Groundwater Application Review Summary Form

Application # G- 19482

SUBJECT: Scenic Waterway Interference Evaluation

TO: Water Rights Section Date 10/16/2025
 FROM: Groundwater Section Gabriela Ferreira
 Reviewer's Name
 SUBJECT: Application G- 19482 Supersedes review of March 13, 2025
 Date of Review(s)

Theis Interference Analysis

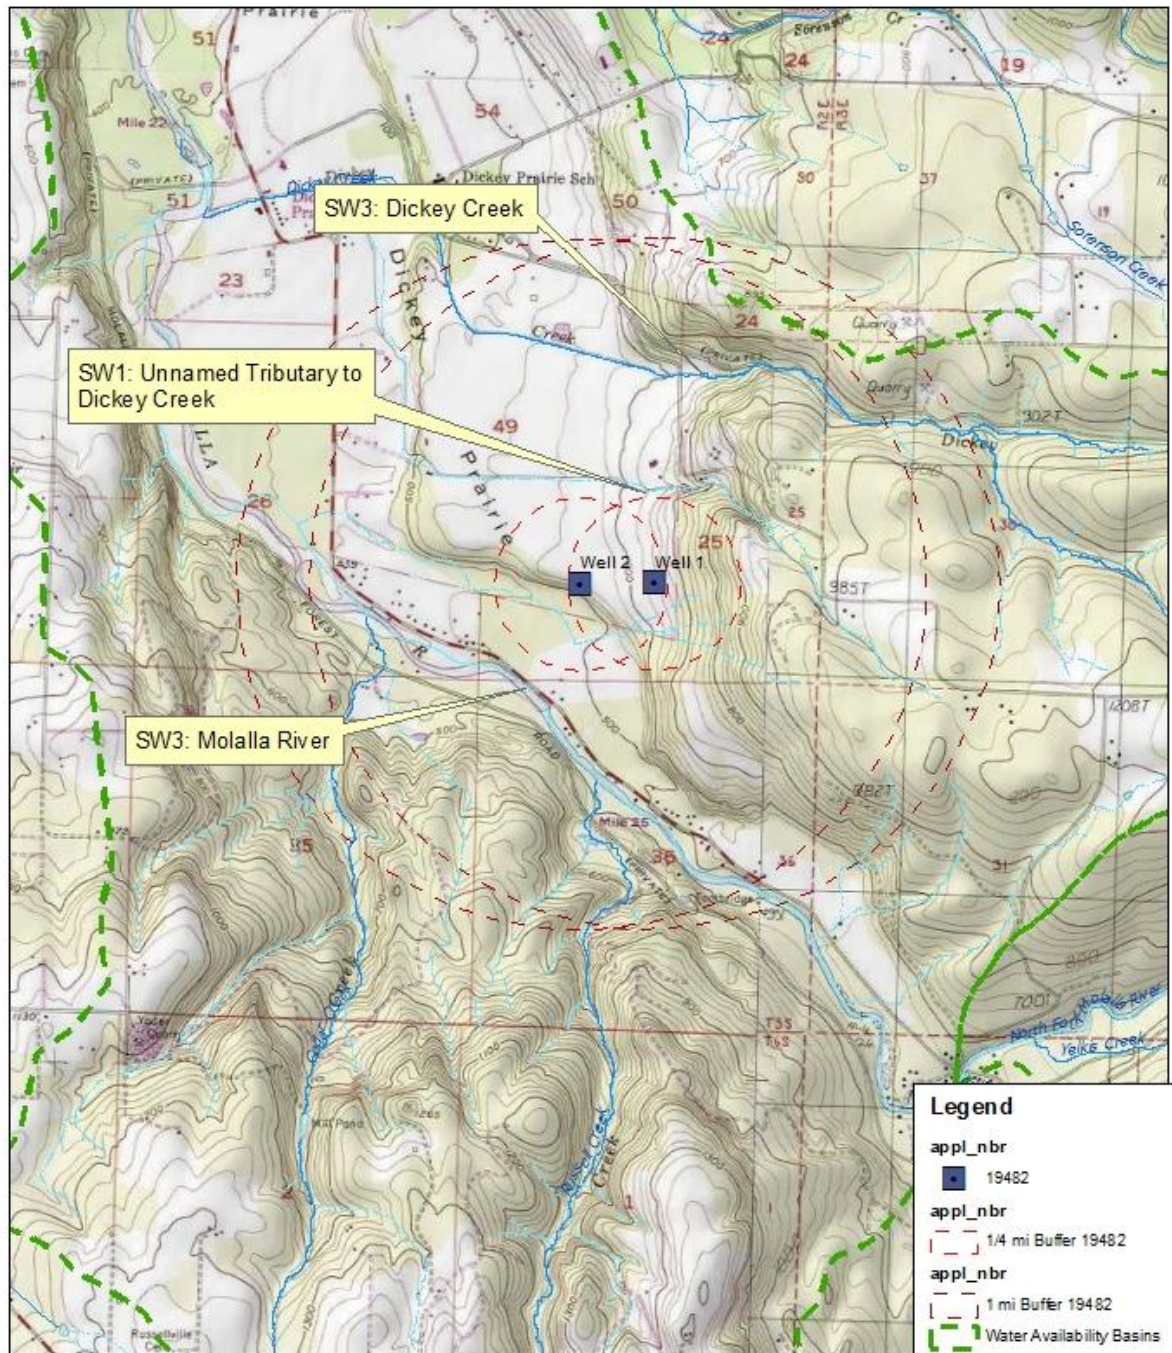
Injury was evaluated against the nearest identified well, identified as CLAC 67959. Despite not fully penetrating the Molalla Formation aquifer system, potential impacts on a potential well were modeled using the attached Theis drawdown analysis

and assuming the full duty and rate of the proposed POA. Transmissivity values are based on published values (Freeze and Cherry 1979; Conlon and others, 2005). Under conservative modeled parameters, acute drawdown in excess of typical permit conditions may occur; therefore, Condition 7RLN is recommended to assess potential future injury concerns.

Permit condition 7RLN is recommended to assess potential future injury concerns, and as a means to monitor long-term groundwater conditions in this area.

Well Location Map

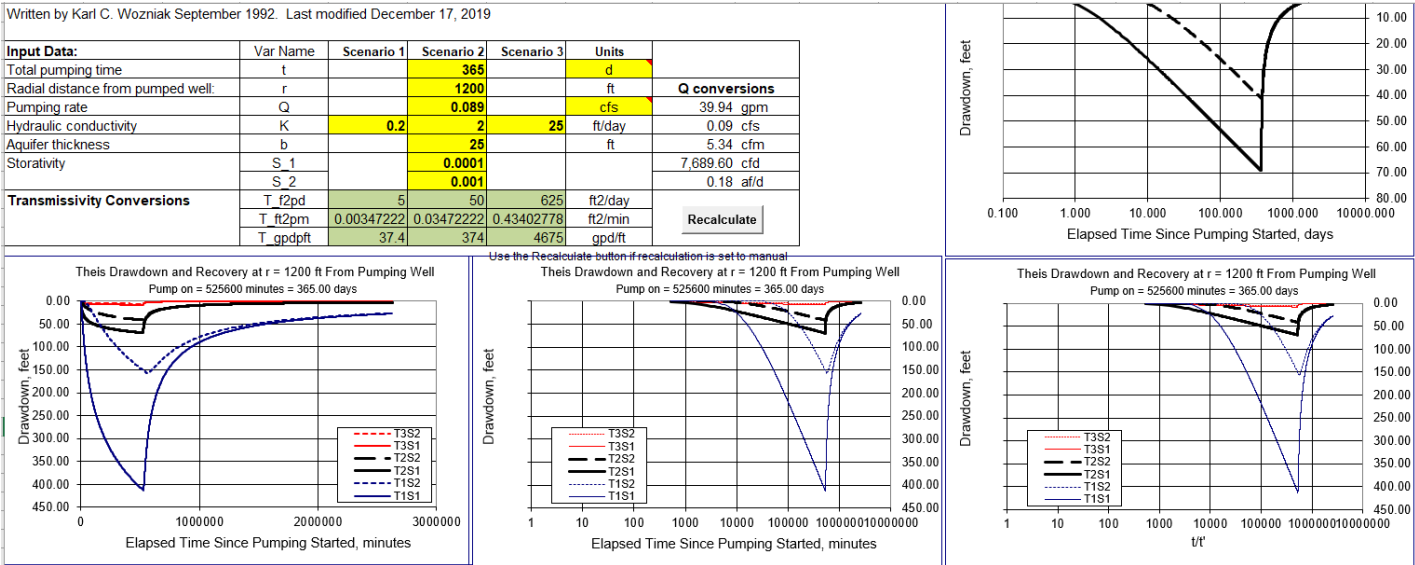
A4. **Comments:** The proposed POAs/POU are located approximately 4 miles southeast of Molalla. The applicant proposes irrigation use on 113.8 acres by two wells to be constructed, for a maximum instantaneous rate of 0.50 cfs (~225 gpm) and maximum annual volume of 243.0 acre-feet.
